## **ADDENDUM 3**

<b>Project:</b>	<b>Leased Space, 22<sup>nd</sup> Floor, Calgary Place, 355 – 4<sup>th</sup> Avenue SW Calgary, Alberta</b>
<b>Solicitation No.:</b>	<b>E0209-141335/A</b>
<b>Dated:</b>	<b>2013-10-10</b>

**Reason for Addendum: Coordination**

**Addendum Issue Date: 2013-11-06**

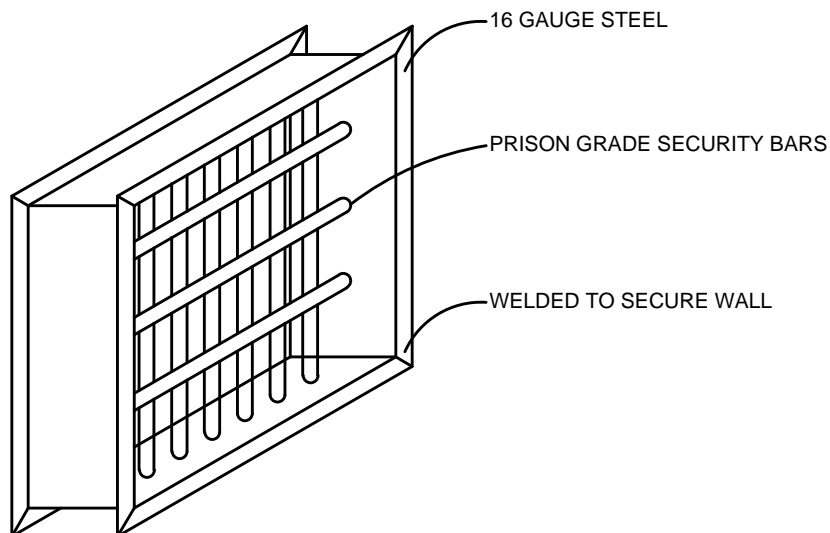
2.3.2 Add General Note 4 and Keynote 5. Refer to attached Drawing PSD-ADD03-M2.06.1.

2.3.3 Add removal of security bars in ductwork that supply the floor above and security bar in ductwork at block wall. Refer to attached Drawing PSD-ADD03-M2.06.2.

1. REMOVE EXISTING GRILLE DIFFUSER. CAP & SEAL DUCT 'AIR TIGHT'.
2. REMOVE EXISTING TRANSFER AIR DUCT.
3. REMOVE EXISTING LOUVRE INCLUDING SECURITY BARS.
4. REMOVE EXISTING EXHAUST FAN INCLUDING BUT NOT LIMITED TO, DUCTWORK, GRILLES, SECURITY BARS, CONTROL WIRING & CO SENSOR.
5. REMOVE EXISTING SECURITY BARS. PATCH DUCTWORK AND MAKE GOOD. TYPICAL.

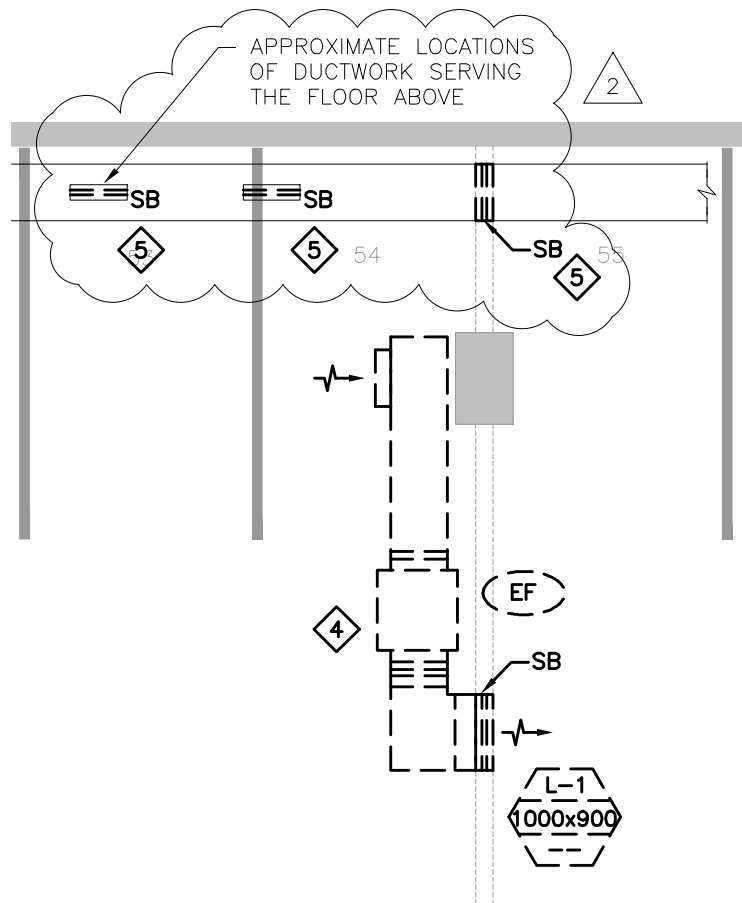
2.3.4 Add removal of security bars in ductwork that supply the floor above and security bar in ductwork at block wall. Refer to attached Drawing PSD-ADD03-M2.06.3.

Sketch #1

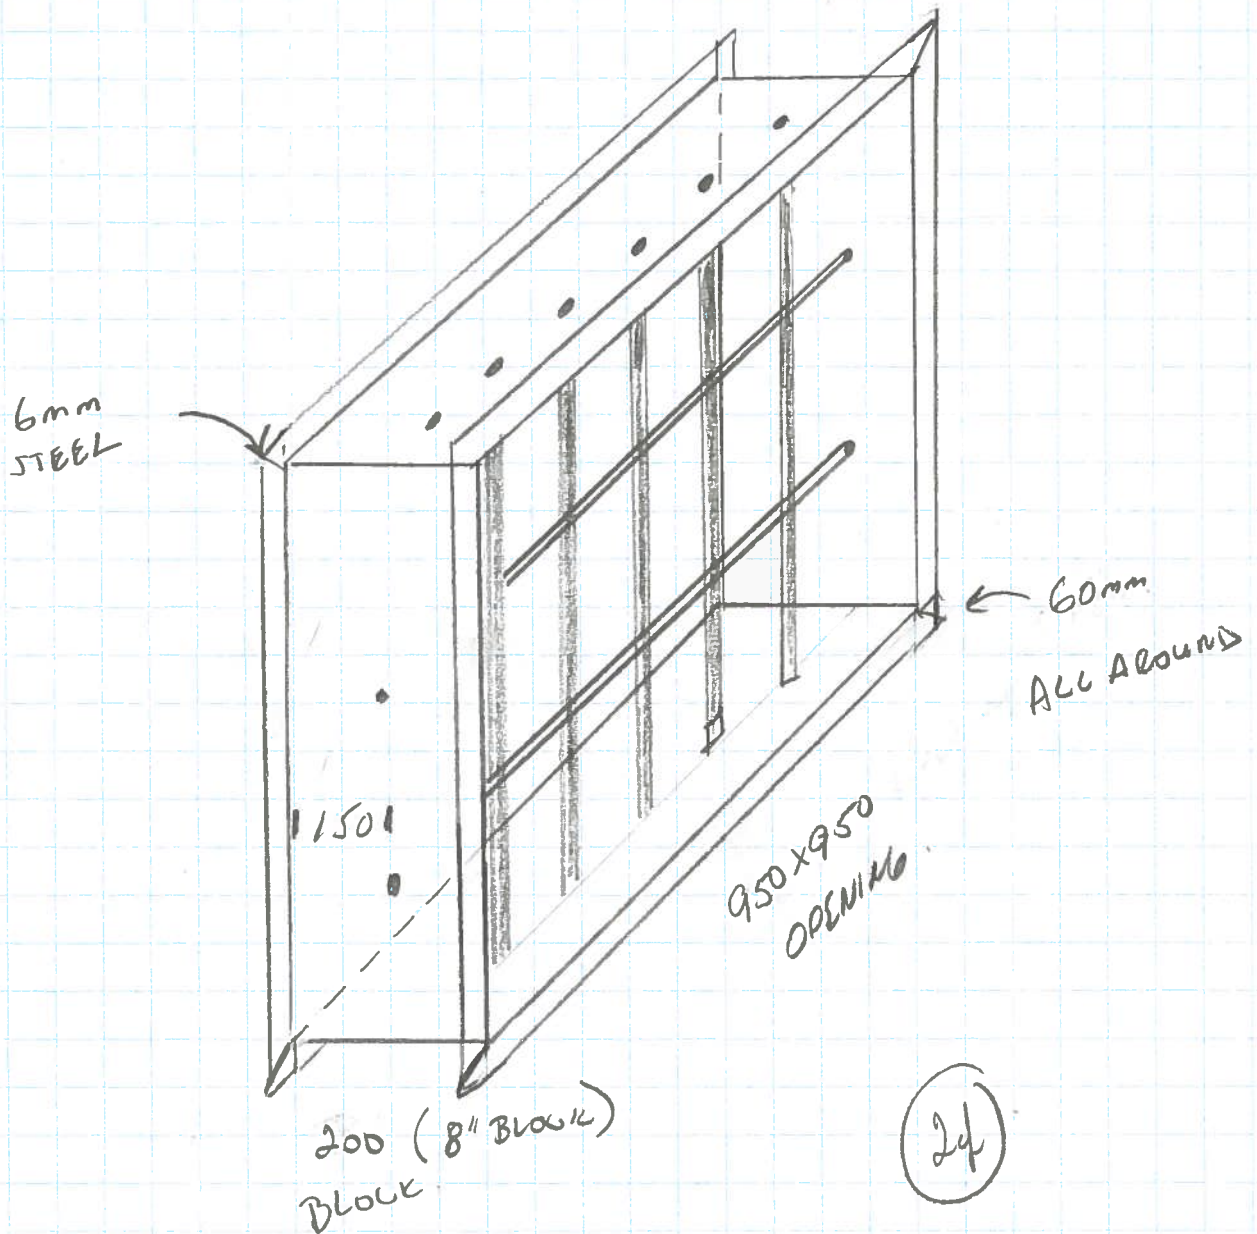
2.3.1 Please note the additional burglar bars in the basement parkade area (2 locations where the duct penetrates the concrete block wall, and 8 outlets along the duct itself. Refer to attached Sketch 1 and Sketch 2.

- ① Fan burglar bar
- ② R/A burglar bar (Basement).

TRANSFER AIR OPENING. PARKING GARAGE.

Sketch #3.

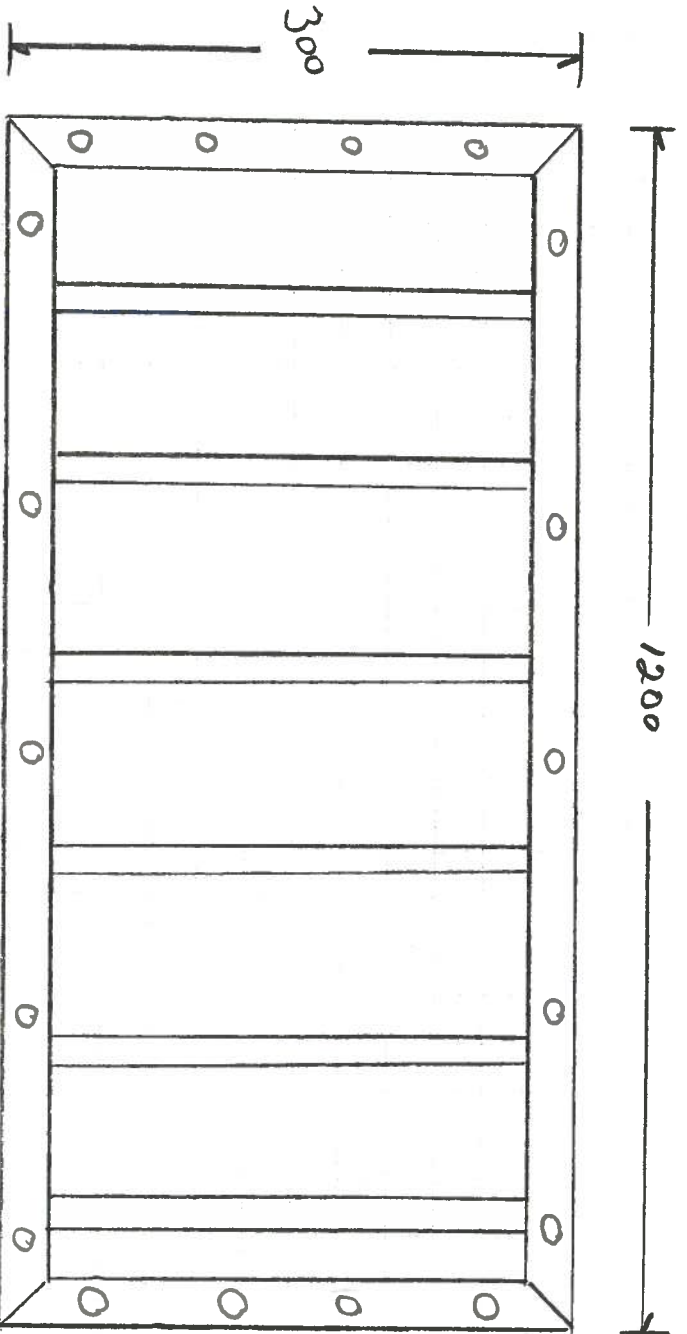
2.2.1 Please note there is a duct along gridline C8 that has burglar bars in the middle. Refer to attached Sketch 3 and Sketch 4. The duct is welded to secure partition. To order to remove the burglar bar, remove section of duct and replace with new section of duct because burglar bar assembly is welded to duct and not bolted. All bolts are tightened and welded.

2.2.2 The burglar bar assembly coupled with the weight of the duct along gridline C8 weighs approximately 1000 lbs.

R/A elbow burglar bar.  
(22nd floor).

Frame made of angle iron 38mm x 38mm x 6mm with mitered corners welded and painted prime color  
 Bars to be 12mm tempered steel rolwell 312 standard hardness  
 Bars to be max 125 on center  
 Bolt holes to be 3.2mm (3/16")  
 We require 2 - 1200x 300 outside frame measurement ( see drawing )  
 2 - 300x 300 outside frame measurement
